# SERVICE BULLETIN

ENGINE - FUEL AND CONTROL - ENGINE FUEL AND CONTROL - FUEL SYSTEM TUBES - ENGINE -  
INTRODUCTION OF REVISED EXTERNAL FUEL TUBE ASSEMBLY WITH WELDED-IN LUG AND AMENDED  
CLIPPING - CATEGORY CODE 7 - MOD.ENG-73-0115

View looking down - Left - Before and after alteration  
Fig.1

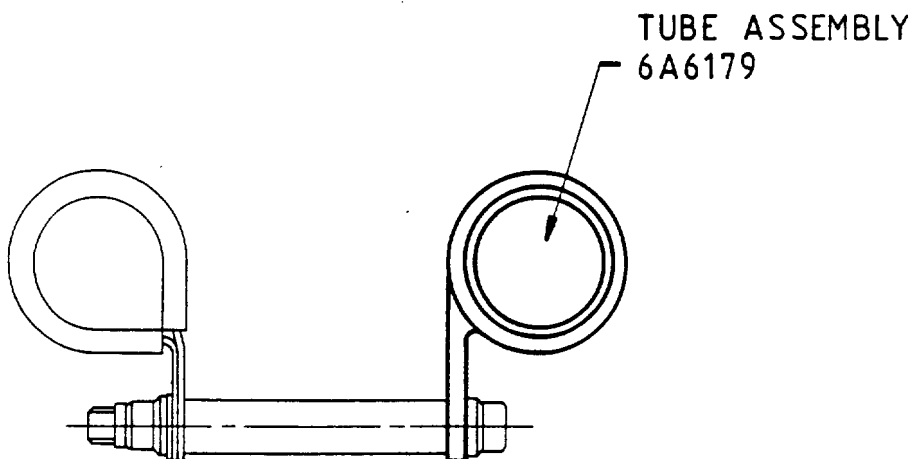
Wear of the HP servo fuel-tube can occur at clip point CP5747. To stop the wear, a clip lug has been welded on the tube at the correct position for CP5747.

- (1) This Service Bulletin contains a changed procedure for attaching the external fuel-tube assembly of the HP servo to clip point CP5747. A permanent location point has been added.

- (a) The external fuel-tube assembly of the HP servo is changed. A welded-in lug has been added to give a permanent position for clip point CP5747.
- (b) Clip points CP5747 and CP6058 have changed.
- (c) The ATA Fig Item numbers for the end connectors and nuts in the external fuel-tube assembly of the HP servo have changed. This change has no affect on the hardware.
